CITY OF FORT PIERCE
DEVELOPMENT REVIEW PACKAGE

835 SEAWAY DRIVE/ TBD

SUBJECT: **Application for Development Review (Major PD Amendment)
 Cumberland Farms @ Harbour Isles
 835 Seaway Drive / TBD**

Scale:	Designed: JAL	Drawn: DF	Checked:	Authorized:
Original Size: ARCH D	Date:	Date:	Date:	Date:
Drawing Number: CFG04.0	Revision:

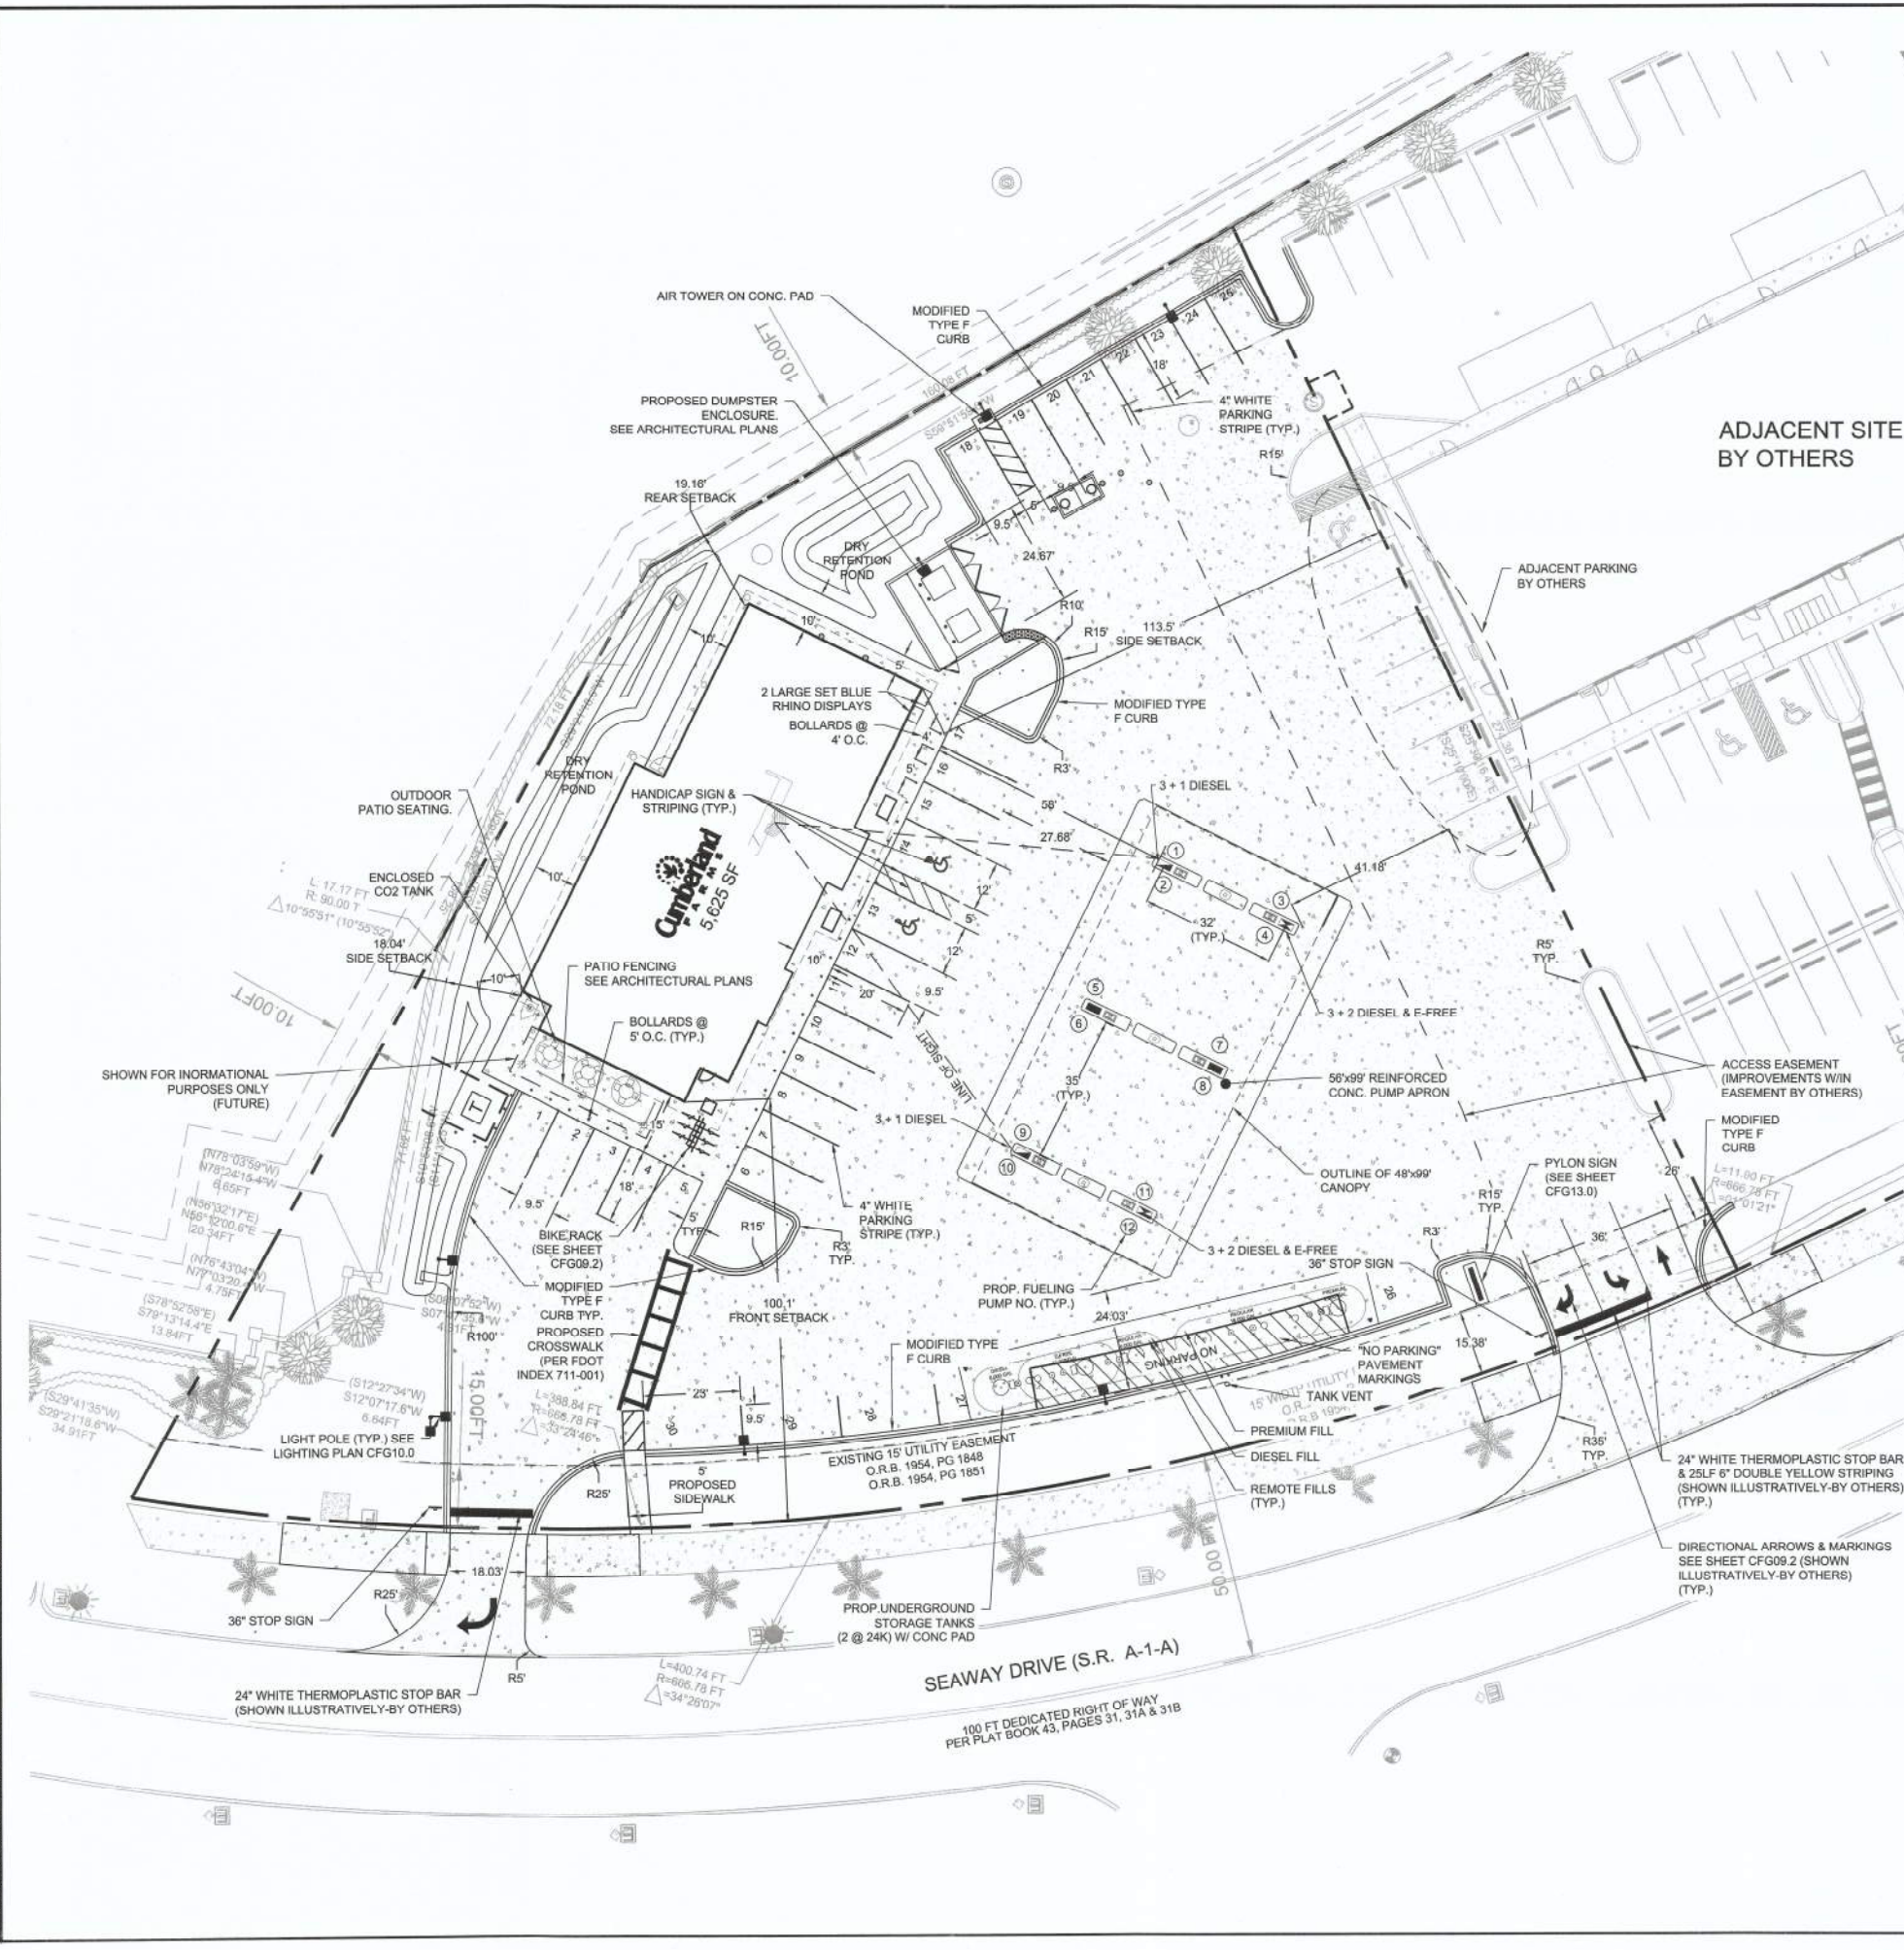
Response: See included traffic study by Mackenzie dated April 19, 2019.
5. Provide bike parking pursuant to City Code 22-60 (f)(1)(a)
Response: Bike parking included on site and shown on sheet CFG04.0, Site Plan.

Response: Boundaries have been revised to match. See Site Plan sheet CFG04.0 and revised survey.
2. Add a note to the site plan specifying the relocation of the two (2) SR A1A streetlights and one (1) royal palm tree must be coordinated with the City of Fort Pierce Engineering Department.

Response: Boundary callouts have been revised to be consistent with latest plat submission, see Sheet CFG04.0, Site Plan.
4. The survey submitted was not certified nor did it identify all recorded easements situated within the limits of the property. Please update the survey to include project boundaries per the recently submitted plat documents, recorded easements, total site area, and any other pertinent information as specified Section 17-27 of the City of Fort Pierce Code of Ordinances.

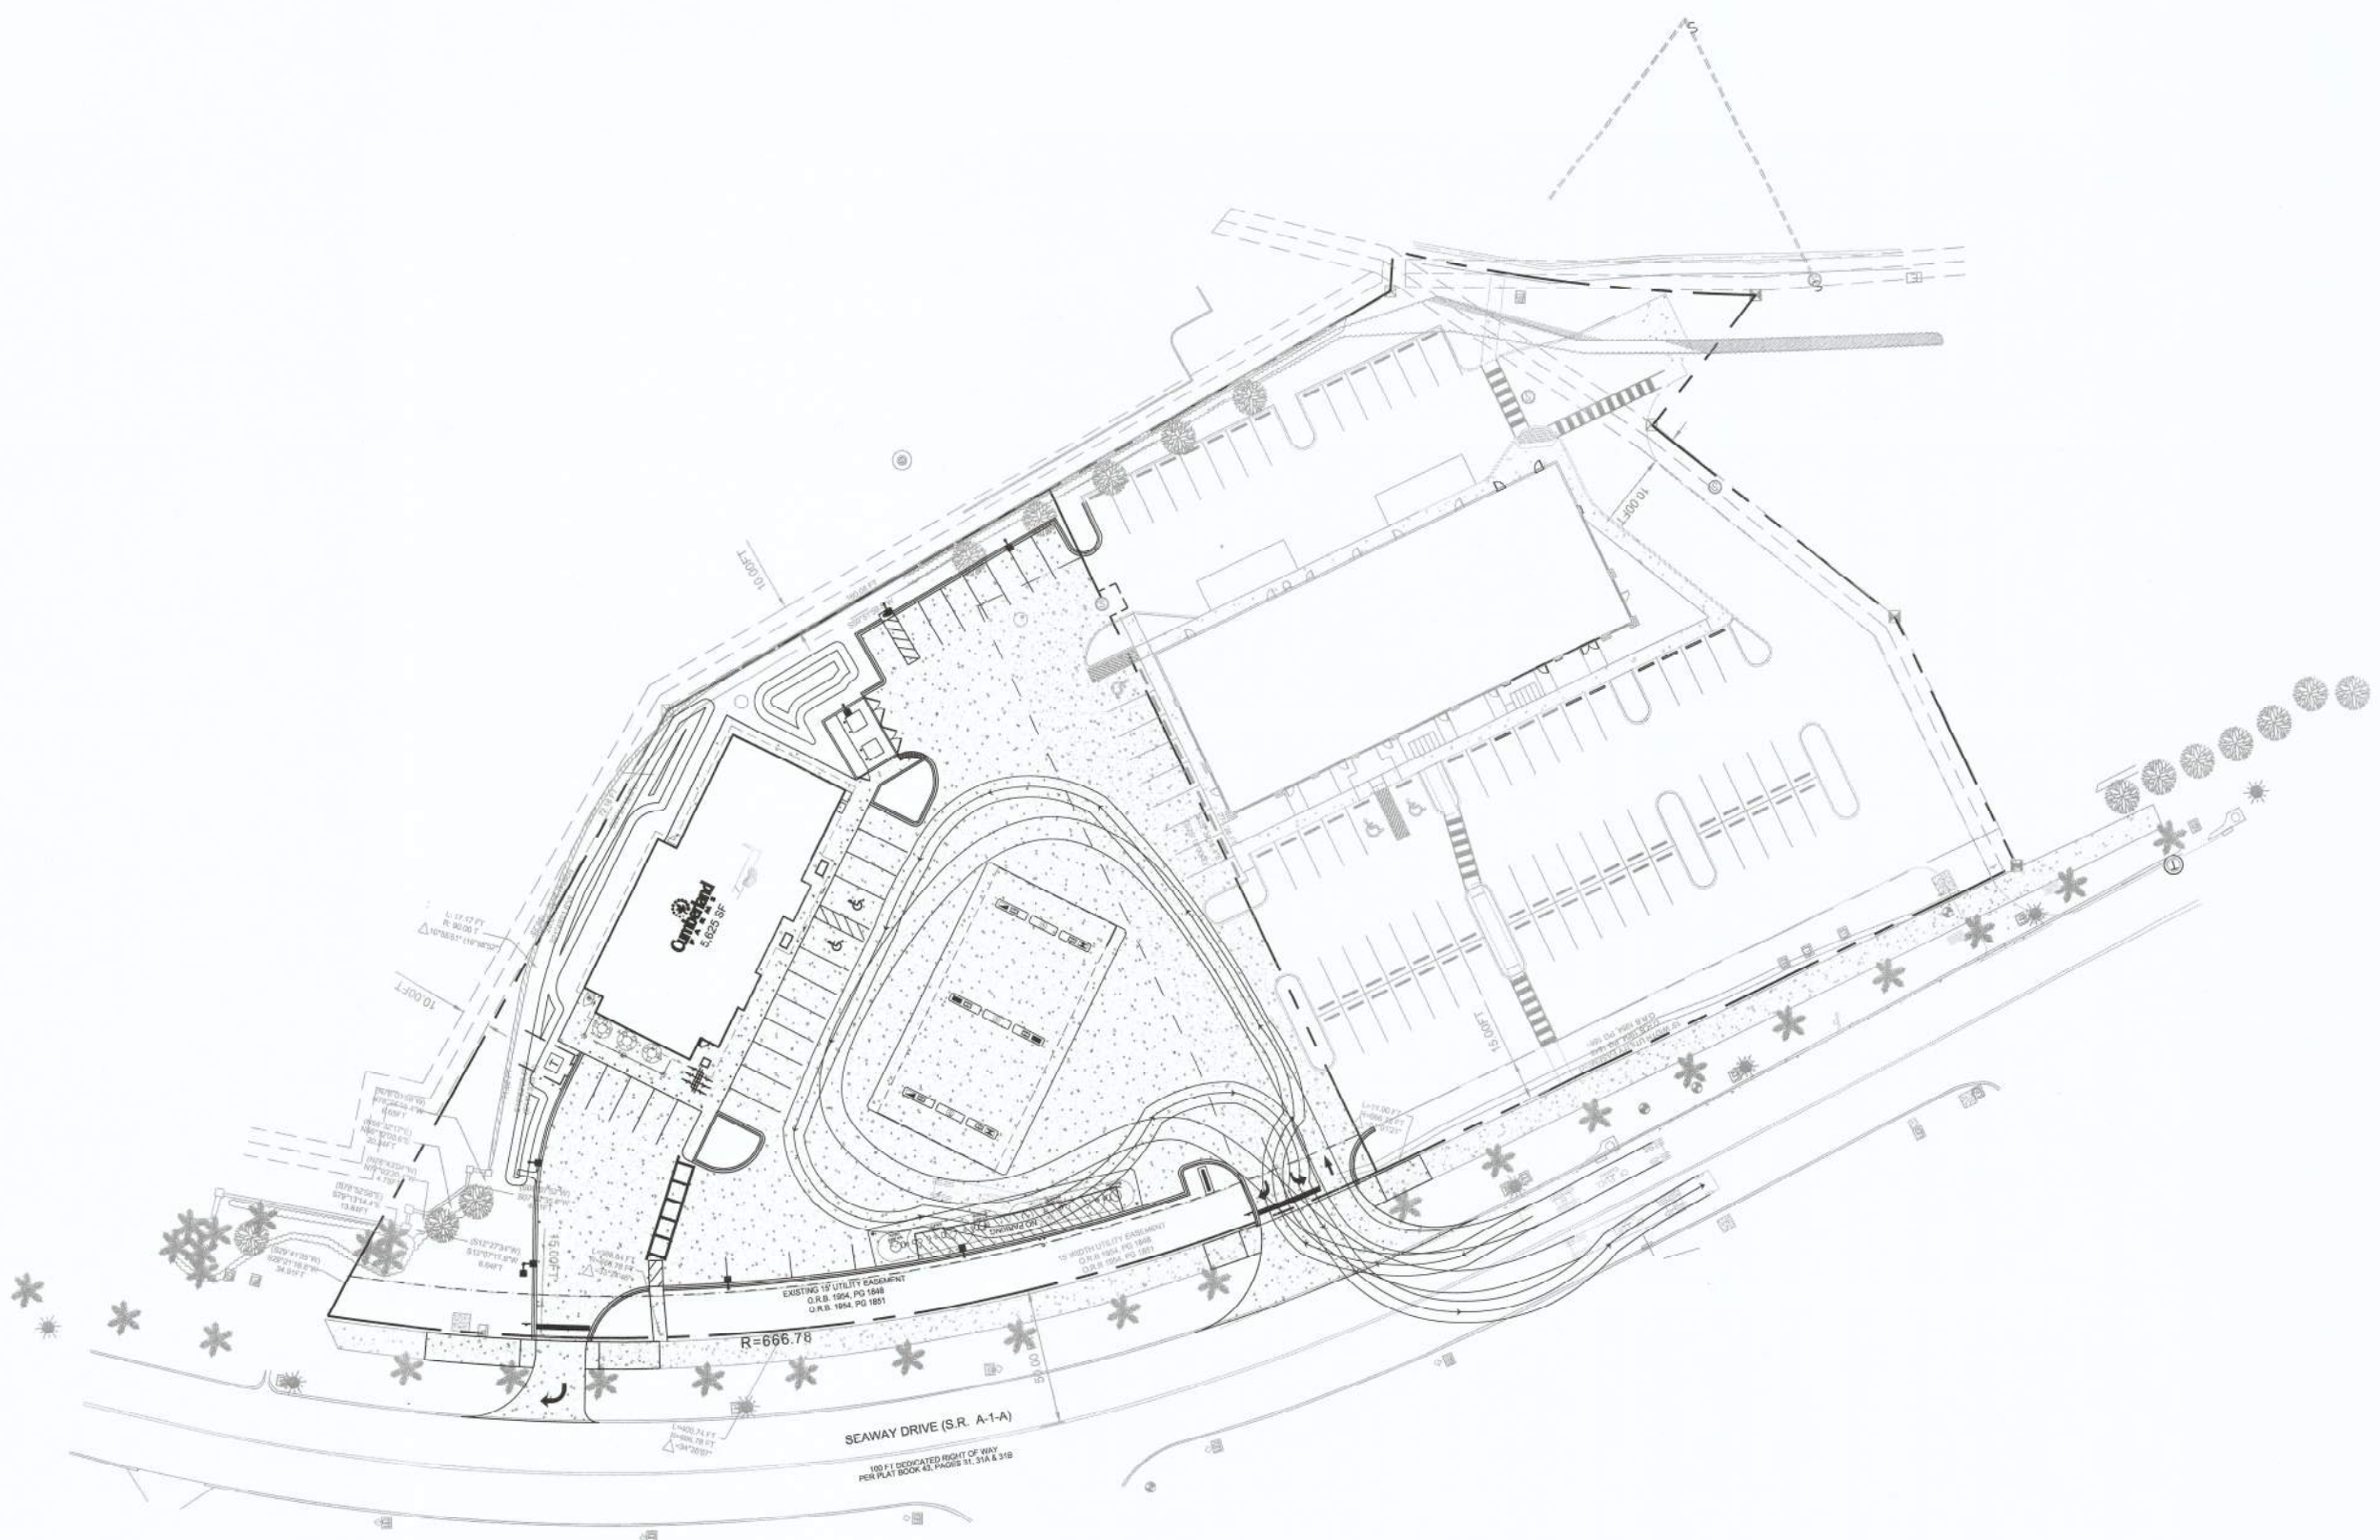
8. Provide a copy of the Auto-Turn analysis depicting the movements of a fuel tanker truck servicing the fuel tanks.
Response: Auto turn analysis performed and provided on Turning Movements Plan, Sheet CFG16.0.
